Report of the Chief Planning Officer

Subject: APPLICATION 15/00651/FU – VARIATION OF CONDITION 18 OF PREVIOUS APPROVAL 14/01511/FU FOR MINOR MATERIAL AMENDMENT RELATING TO USE OF EXTERNAL FACING MATERIAL AT LEEDS WEIR

**Justification for Change to Material
Finishes at Crown Point Weir**

LFD-ARP-Z1-W1-RP-CC-00001

Figure 1: proposed cross section through the weir.

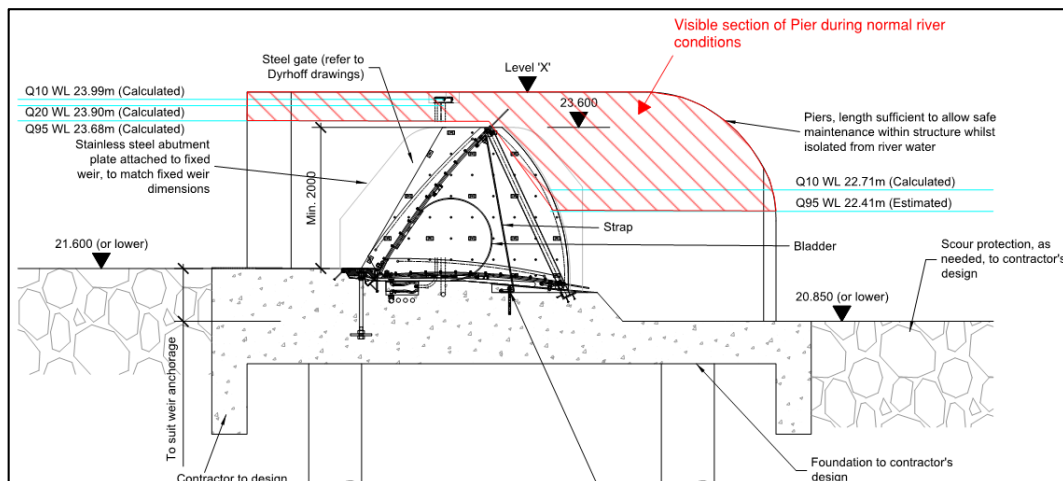
The gates will be predominantly submerged and in normal conditions (Q95) the downstream face and upper 420mm of the dividing piers will be visible (refer to figure 1). That is to say, under normal river conditions only a limited portion of the pier would be visible.

The visual impact is limited as in normal flow conditions only a limited portion of the piers would be visible.

Figure 7: Downstream visual representations of Concrete finishes

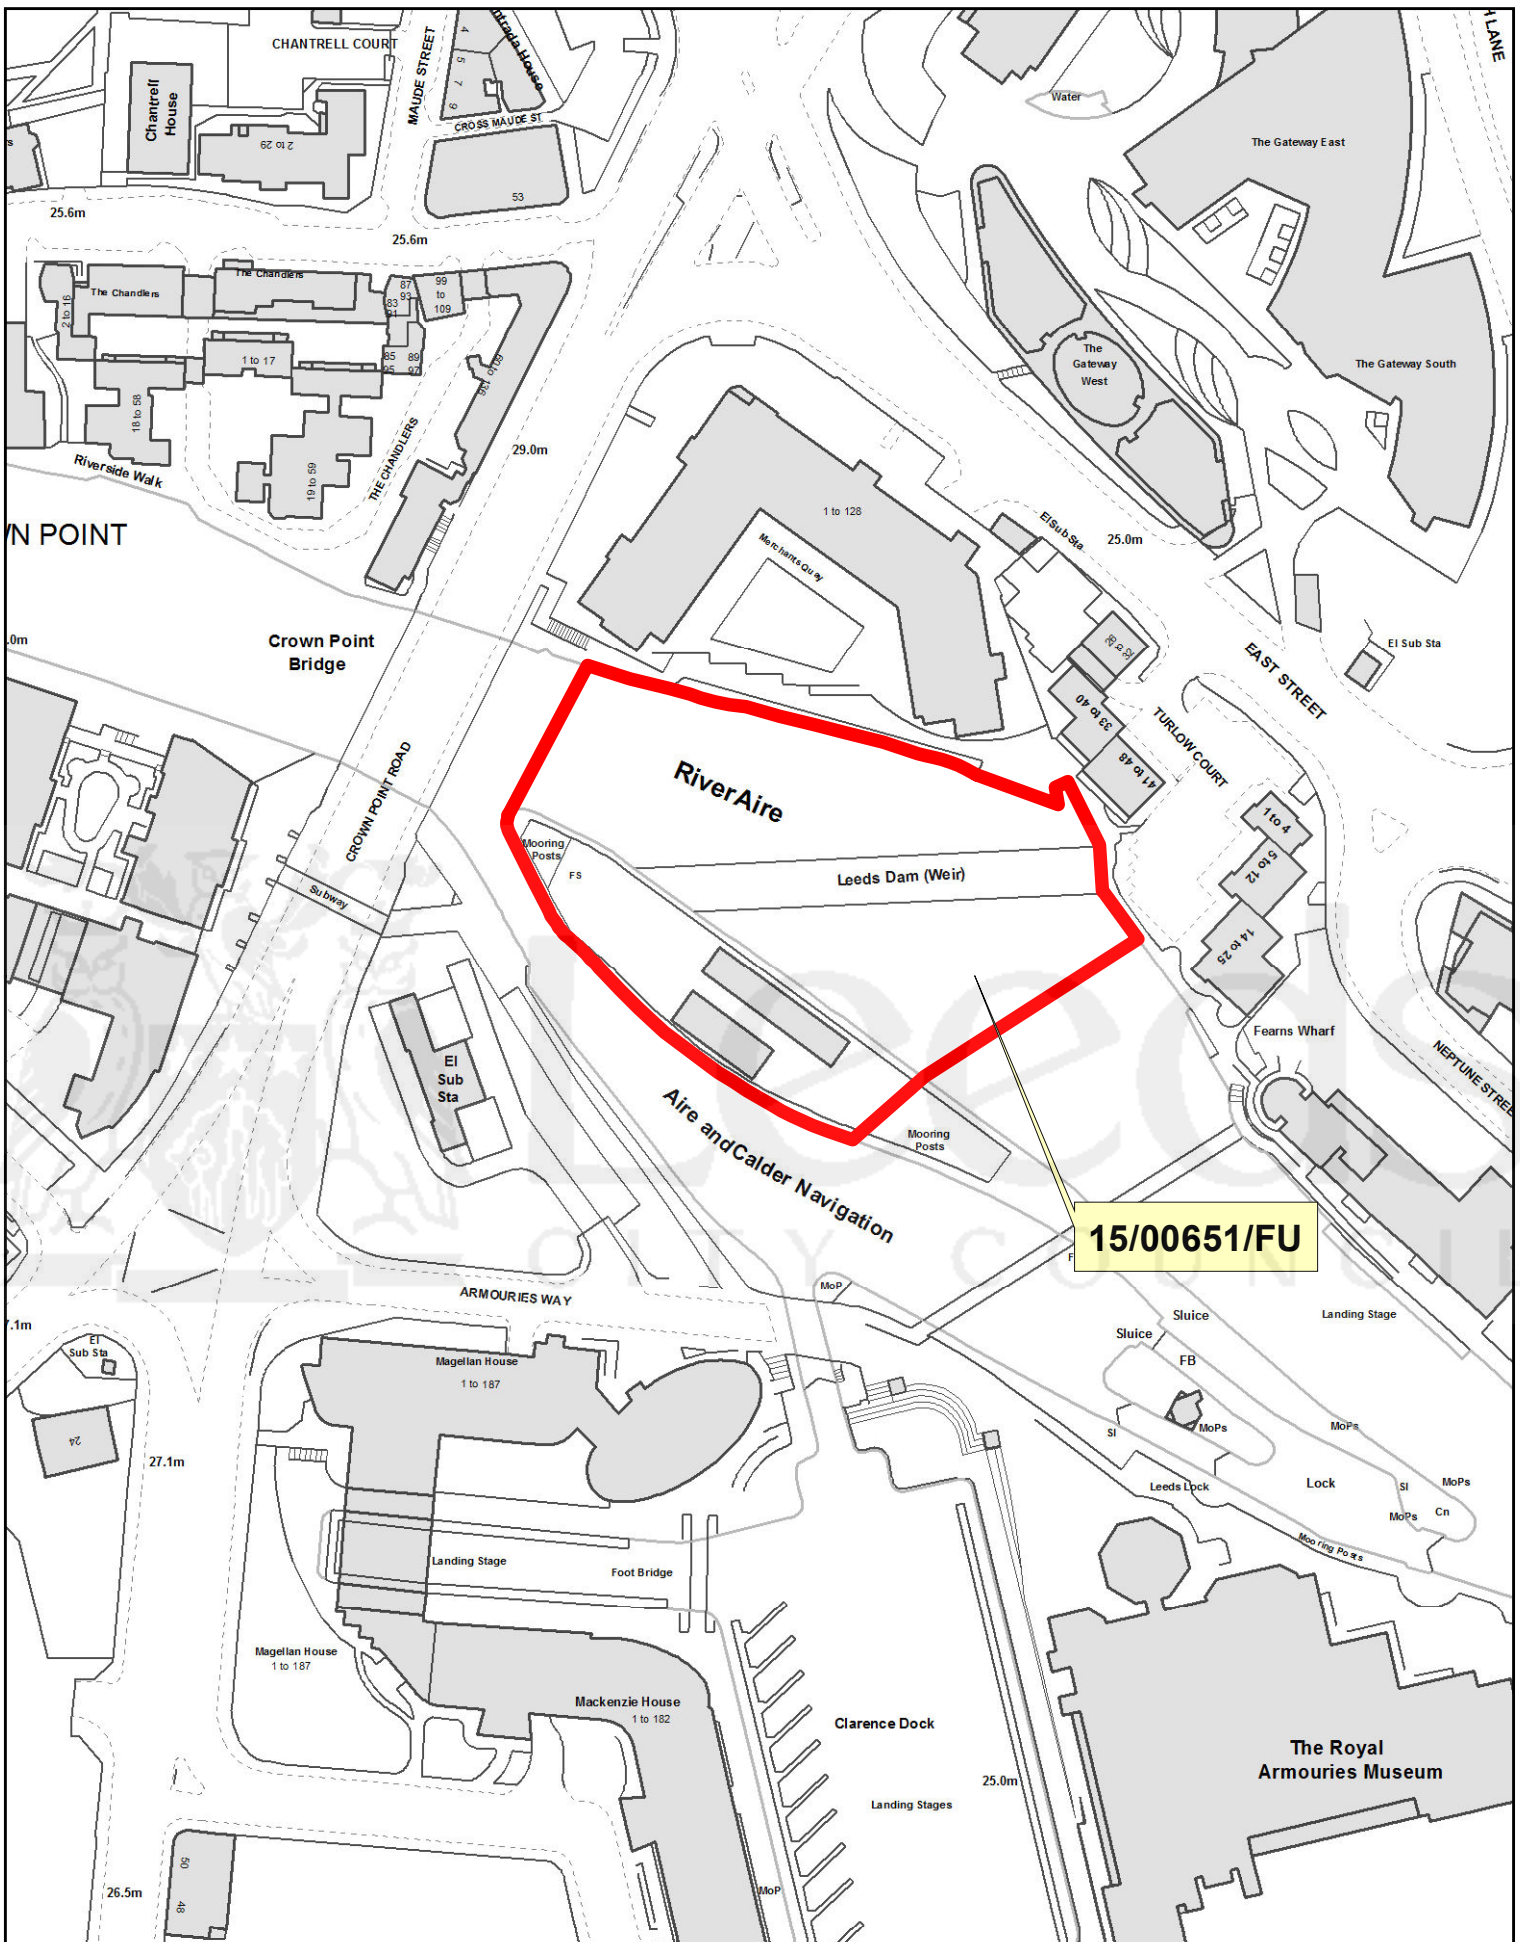
In this section a number of visualisations have been prepared to provide an indication of how the weir would fit in its surrounding based on masonry and concrete finishes.
